CITY OF ALBUQUERQUE

RE: 10538 Dover St. NW
Grading and Drainage Plan
Engineer's Certification Date: 01/17/20
Engineer's Stamp Date: 08/21/19
Hydrology File: A12D031

DRAINAGE AND TRANSPORTATION INFORMATION SHEET (REV 6/2018)

ENGINEER'S SEAL	10538 DOVER	DRAWN BY: WCUJ
	GRADING AND DRAINAGE PLAN	DATE: 8-21-19
DAVID SOULE P.E. #14522	Rio Grande Engineering 1606 CENTRAL AVENUE SE SUITE 201 ALBUQUERQUE, NM 87106 (505) 872-0998	2109068-LAYOUT-8-21-19
		SHEET #
8/21/19		JOB #
		2109068

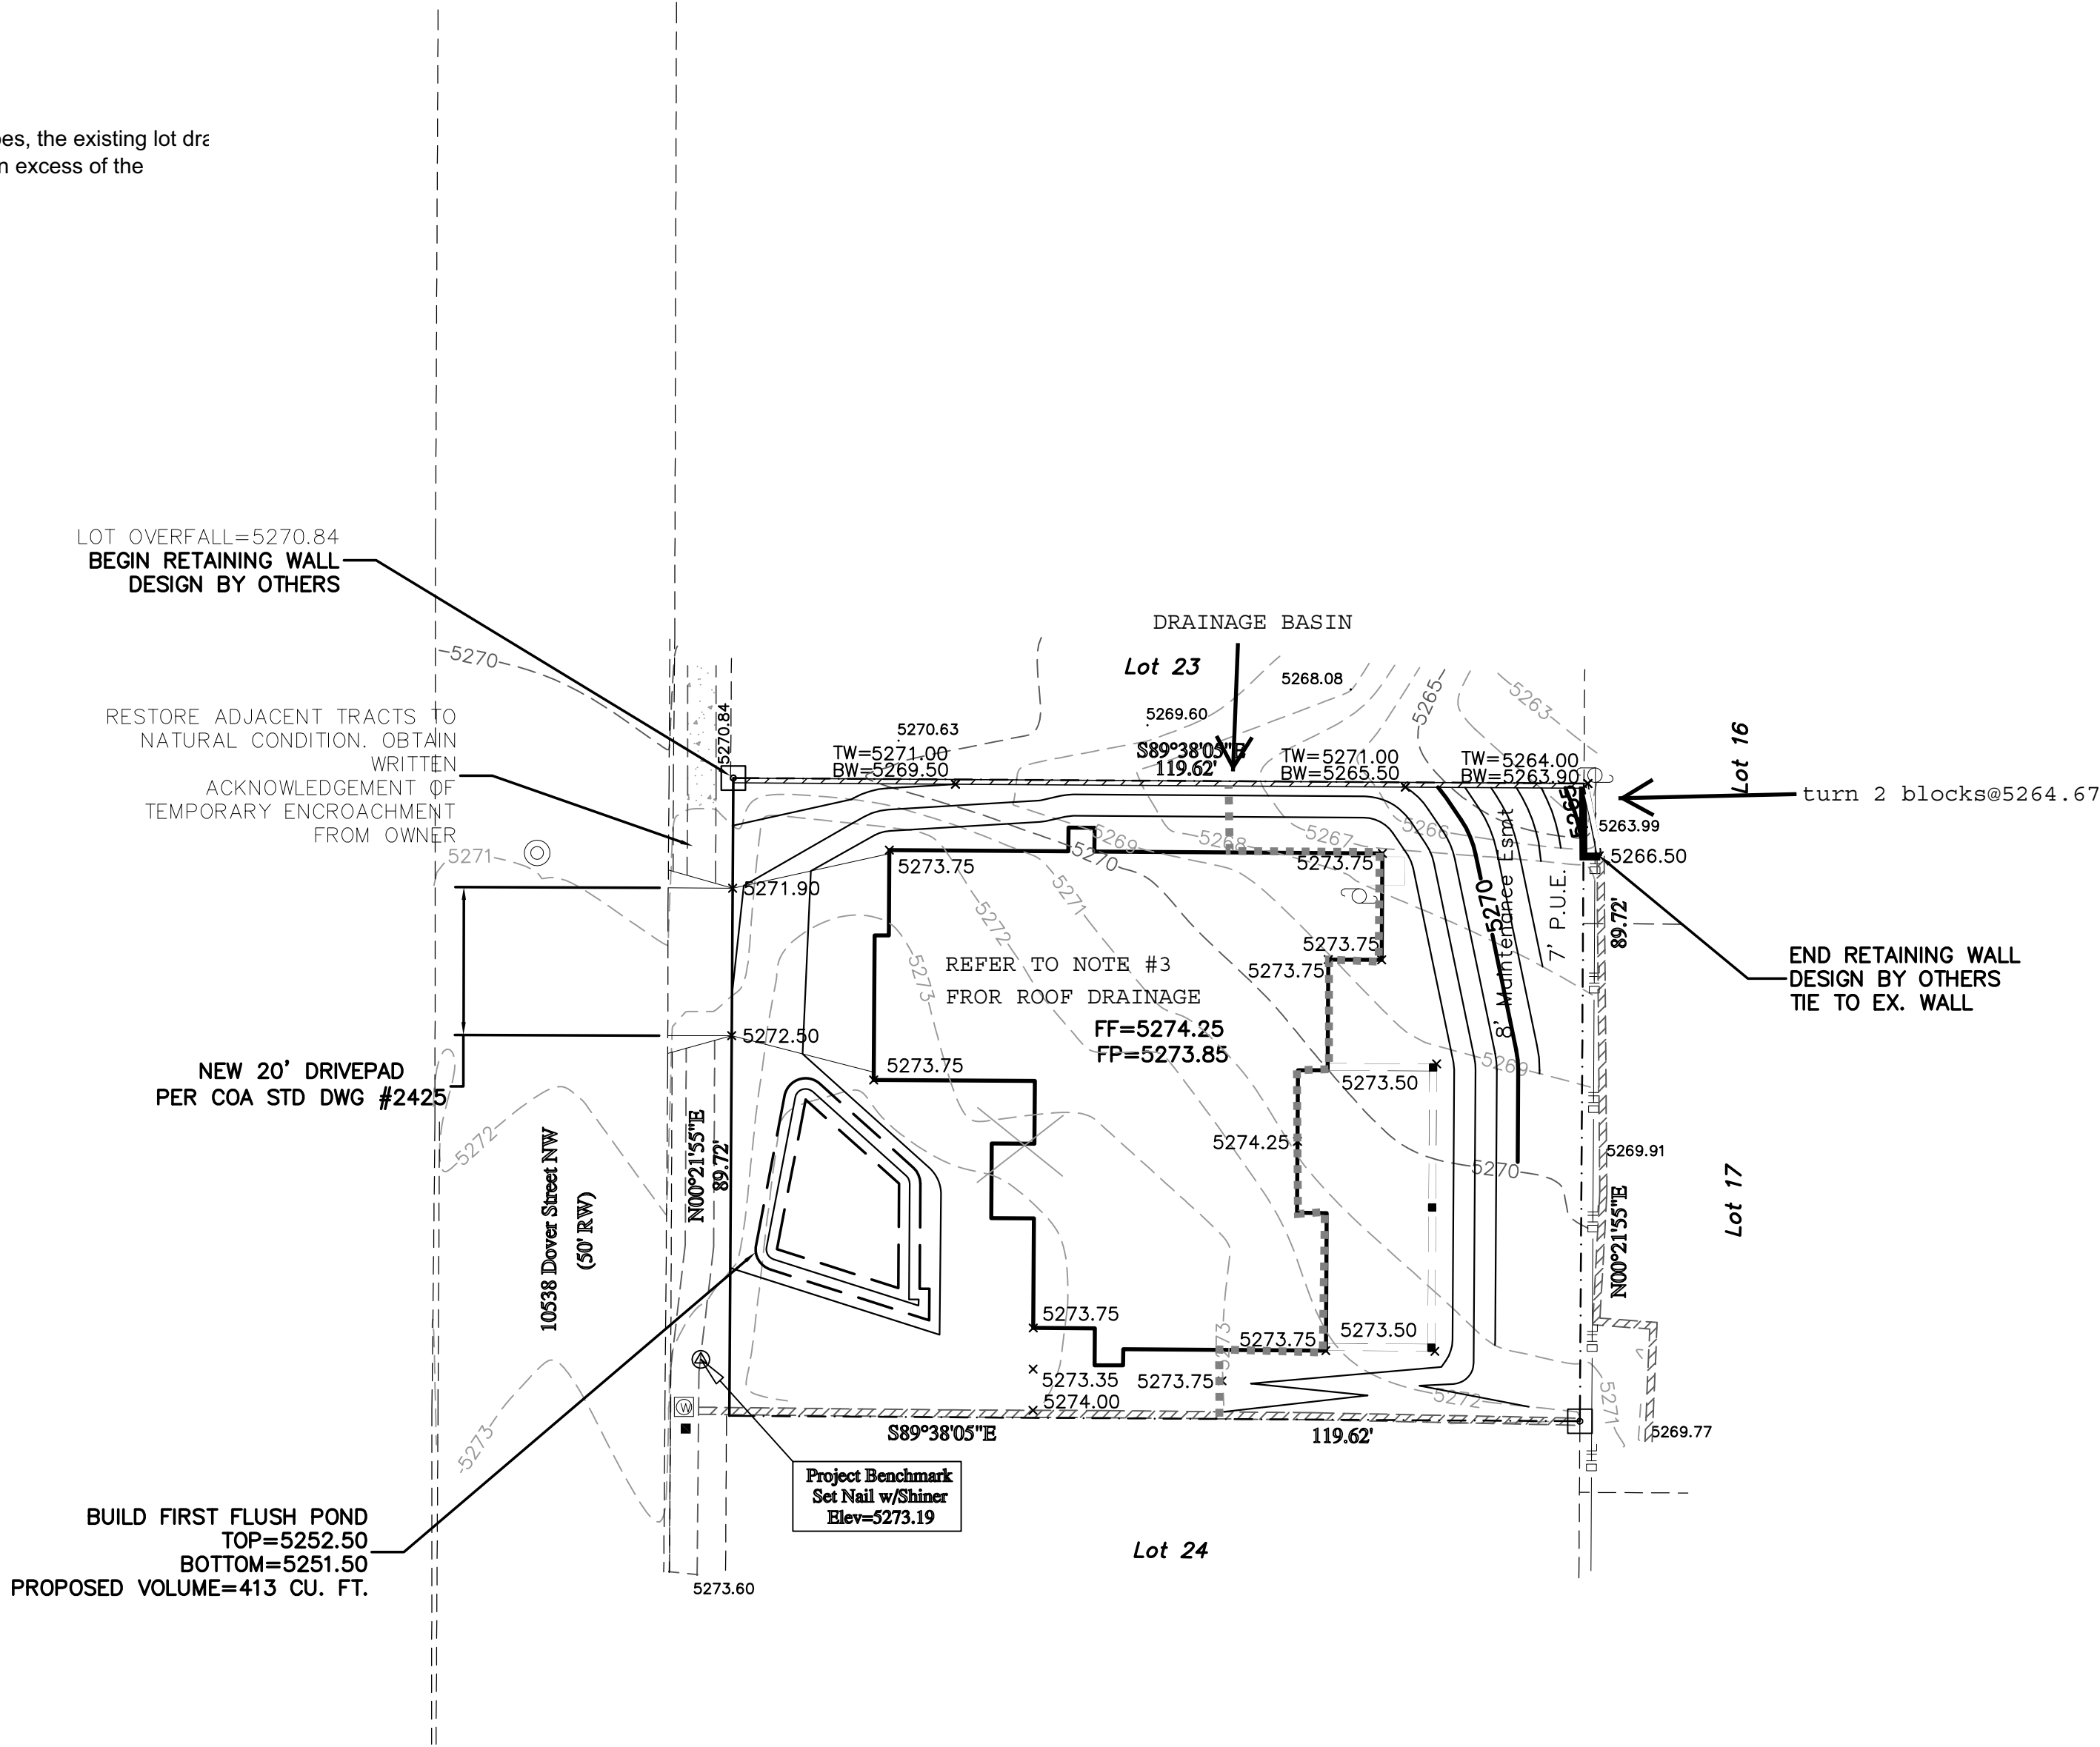
Based upon the information provided in your Certification received on 02/10/20 and site photos sent on 02/12/20, the above referenced Certification is acceptable for Building Pad Certification for 10538 Dover St. NW.

Prior to approval in support of Permanent Release of Occupancy by Hydrology, Engineer Certification per the DPM checklist will be required. Also a formal Elevation Certificate needs to be submitted to Hydrology.
